FINAL PLAT  
 SPENCER'S 2ND ADDITION  
 WICHITA, SEDGWICK COUNTY, KANSAS  
 2003

RE: SUB 2003-01 -- One-Step Final Plat of Spencer's Second Addition

**STAFF REPORT**  
**(ONE-STEP FINAL PLAT)**

**CASE NUMBER:** SUB 2003-01 -- SPENCER'S SECOND ADDITION

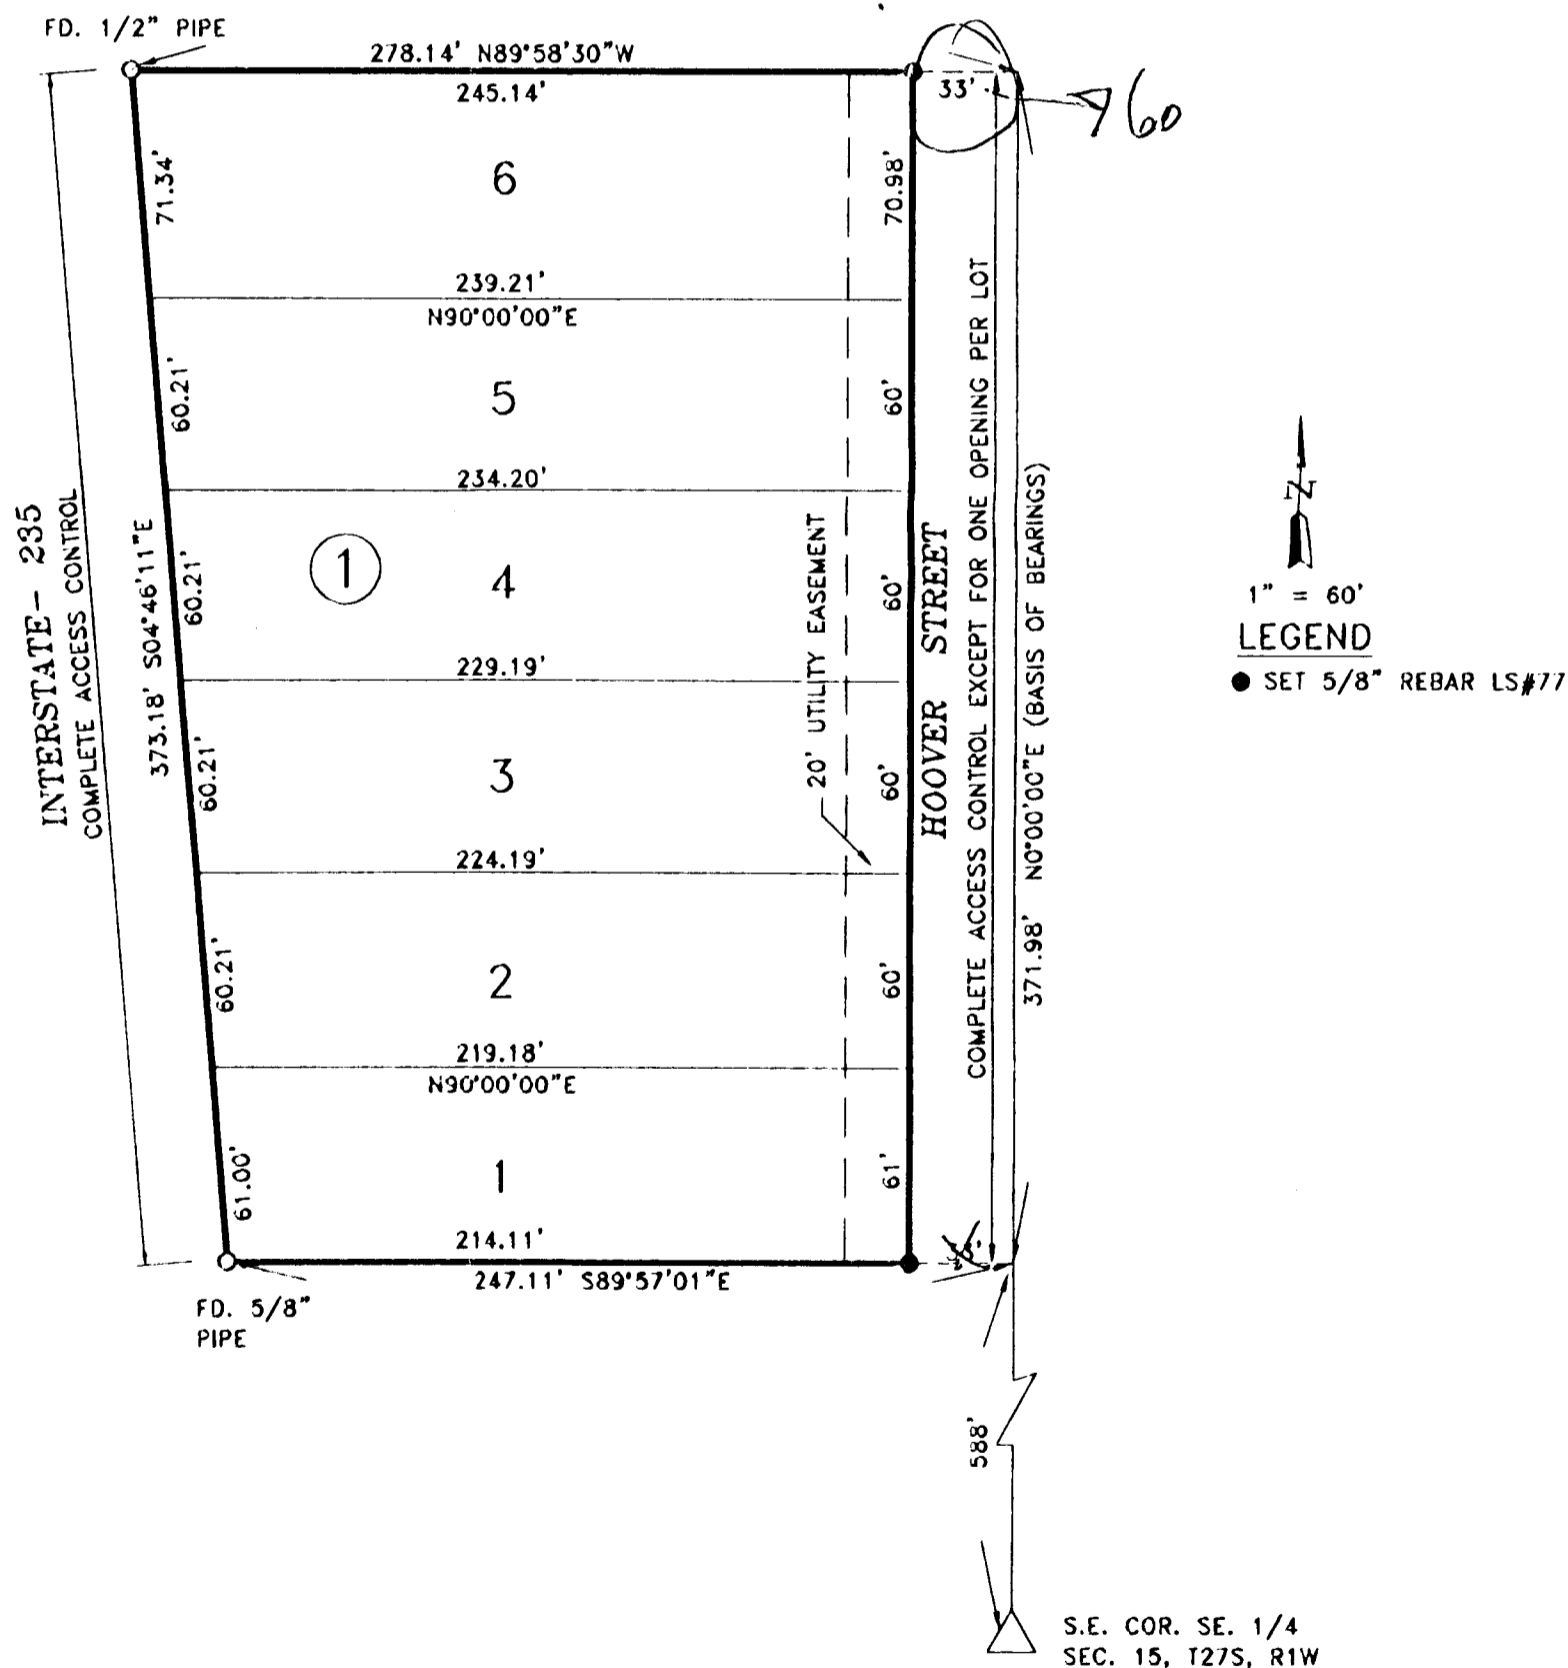
- A. This plat will be subject to approval of the associated zone change and any related conditions of such a change. Prior to this plat being considered by MAPC, the zone change will need to be approved.

- B. Municipal water services are available. The applicant shall guarantee the extension of sanitary sewer to serve the lots being platted. City Water and Sewer Department advises that the property has not been assessed for the water main. The applicant will need to pay fees in lieu of assessment or submit an application to the Director of Water and Sewer Department for a waiver of the fees.

- D. City Engineering has approved the drainage plan. As drainage will be directed onto I-235, a letter shall be provided from KDOT indicating their agreement to accept such drainage.

- E. The plat proposes six access openings along Hoover. Traffic Engineering has approved the access controls.
- ~~G. The joint access openings shall be established by separate instrument. Initial construction responsibilities and future maintenance of the driveways within the easements should also be addressed by the text of the instrument.~~

- H. Traffic Engineering has requested the dedication of additional right-of-way along Hoover to conform with the 60-ft half-street right-of-way required by the Access Management Regulations.

- I. The Applicant shall guarantee the paving of Hoover.
- J. This property is within a zone identified by the City Engineers' office as likely to have groundwater at some or all times within 10 feet of the ground surface elevation. Building with specially engineered foundations or with the lowest floor opening above groundwater is recommended, and owners seeking building permits on this property will be similarly advised. More detailed information on recorded groundwater elevations in the vicinity of this property is available in the City Engineers' office.

- L. The signature line for the City Clerk needs to be revised to reference "Pat Graves".
- M. On the final plat, the MAPC signature block needs to reference "Dale Miller, Secretary".

- N. The year "2003" needs to replace "2002" within the signature blocks.
- O. Approval of this plat will require a waiver of the lot depth to width ratio of the Subdivision Regulations for all of the lots. The Subdivision Regulations state that the maximum depth of all residential lots shall not exceed 2.5 times the width.

- P. The plattor's text shall include language that a drainage plan has been developed for the plat and that all drainage easements, rights-of-way, or reserves shall remain at established grades or as modified with the approval of the applicable City or County Engineer, and unobstructed to allow for the conveyance of stormwater.

- V. Perimeter closure computations shall be submitted with the final plat tracing.
- W. Recording of the plat within thirty (30) days after approval by the City Council and/or County Commission.
